**Planning Application for
Minor Relaxation of Building Height Restriction for Residential Development
at No. 5 Lincoln Road,
Kowloon Tong, Kowloon
(New Kowloon Inland Lot No. 714)
(Planning Application No. A/K18/349)**

Response-to-Comments

Revised B/F and G/F Plans
and
Swept Path Analysis
on the Loading and Unloading Bay for Goods Vehicles

BASEMENT FLOOR PLAN

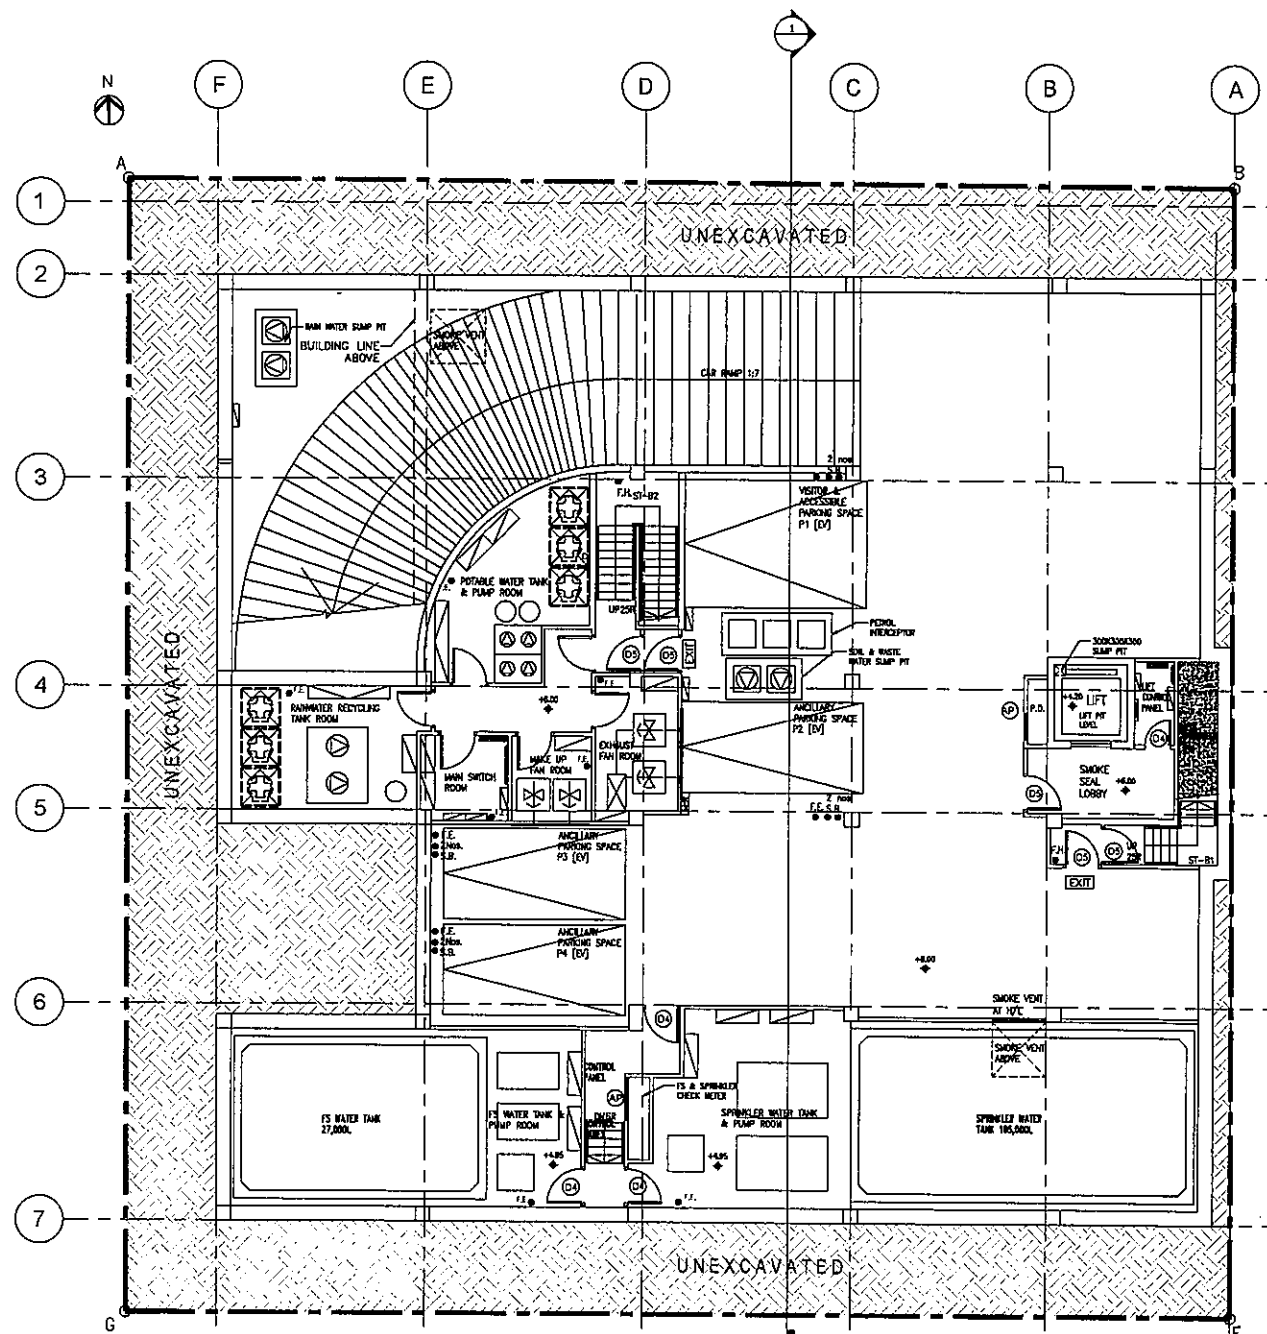
| | Departmental Comments | Responses |
|-------|---|---|
| (ii) | Instead of the 1 no. of loading/unloading space for private car as proposed by the applicant, 1 no. of loading / unloading space for goods vehicle shall be proposed, the dimension of the loading / unloading space for goods vehicles shall refer to section 3(g), Table 11, Chapter 8 of HKPSG; and | Please note that 1 no. of loading / unloading space for light goods vehicle is proposed at G/F in replacement of the previously proposed 1 no. of loading/unloading space for private car at B/F. Please see the revised B/F and G/F plans at Appendix 2 . |

SWEEP PATH ANALYSIS FOR LOADING AND
UNLOADING CAR PARKING SPACE

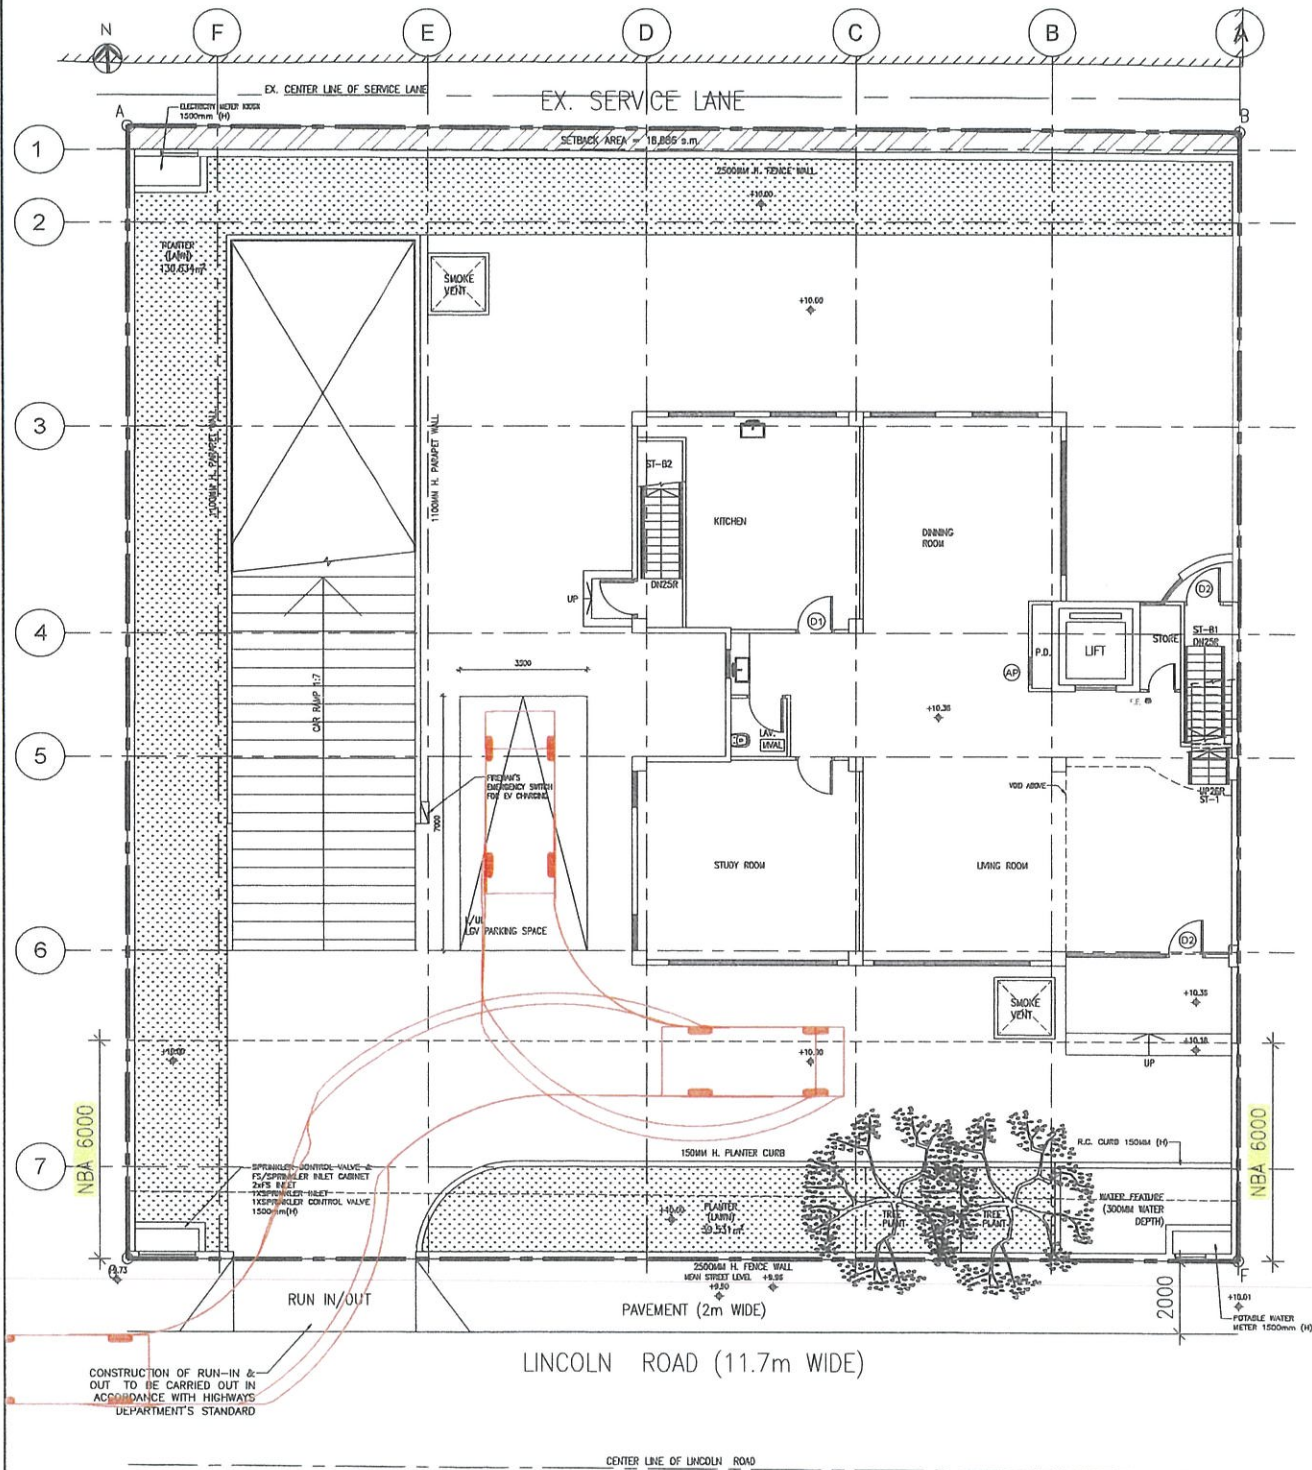
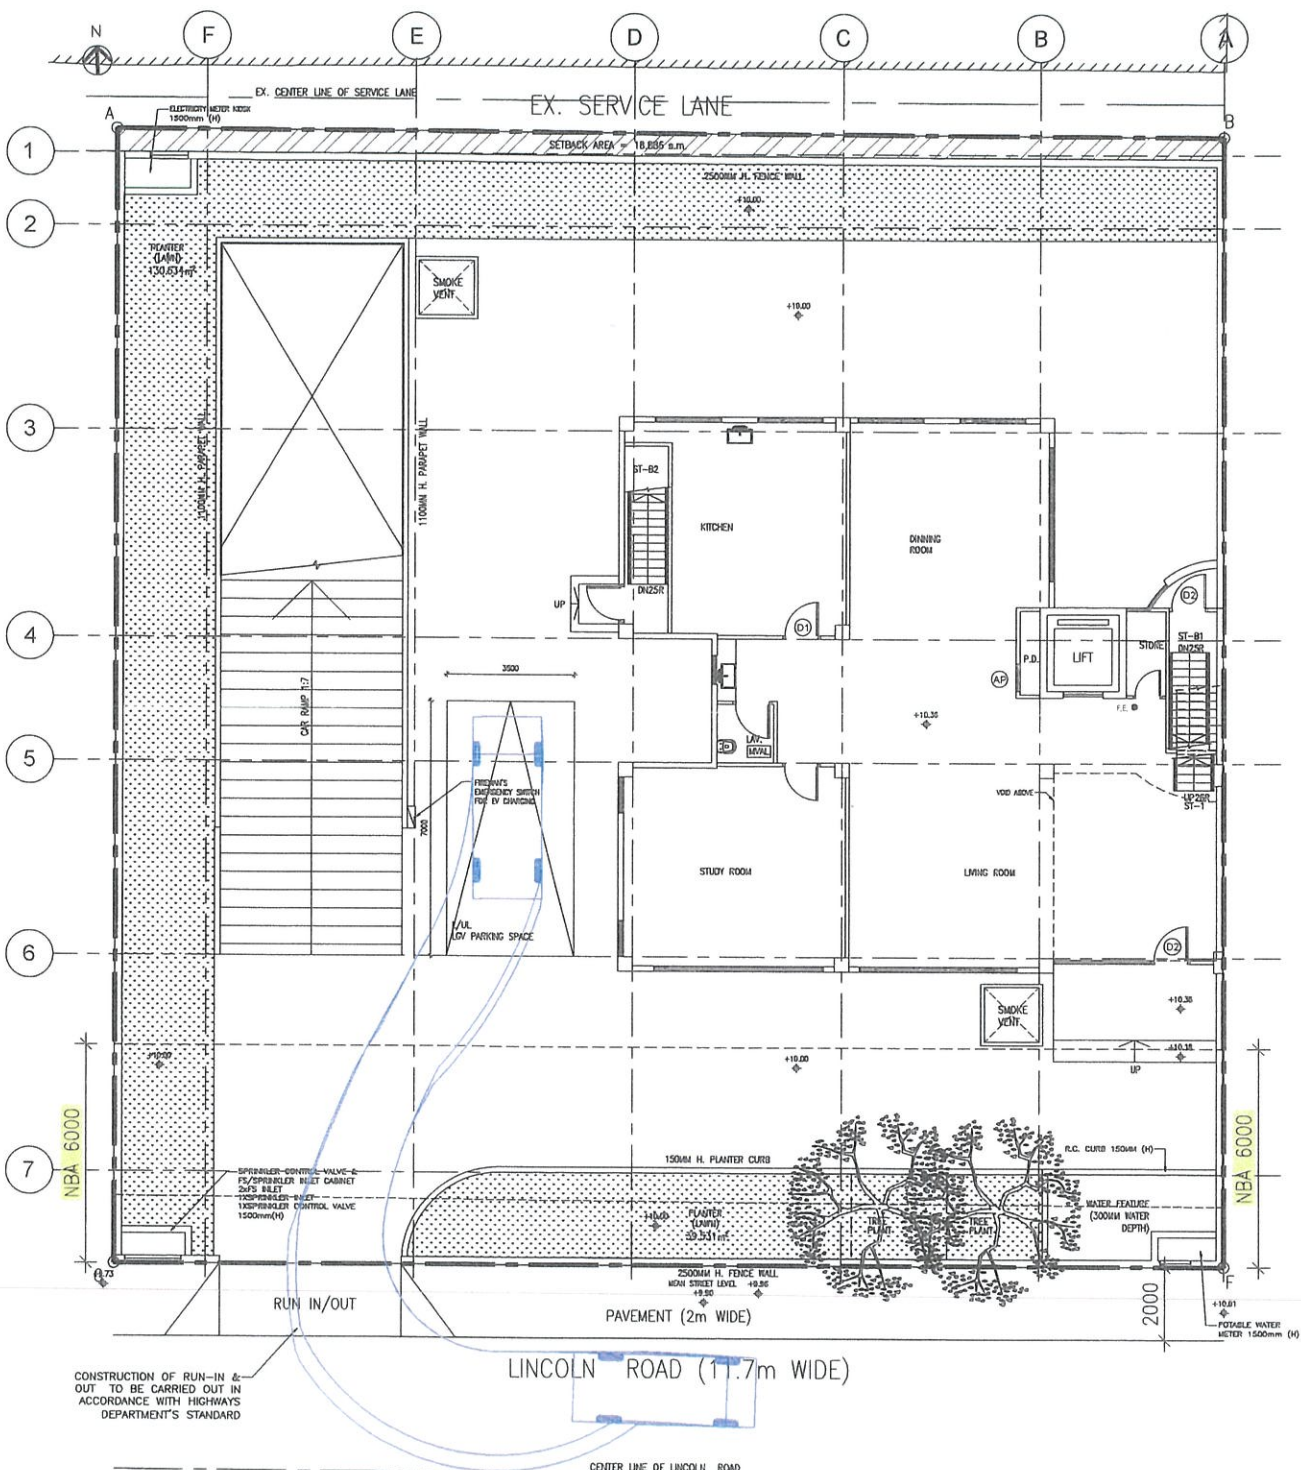
| | Departmental Comments | Responses |
|-------|---|---|
| (iii) | The applicant shall provide swept path analysis on the loading and unloading bay for goods vehicles. | Please see the Swept Path Analysis at Appendix 2 . |
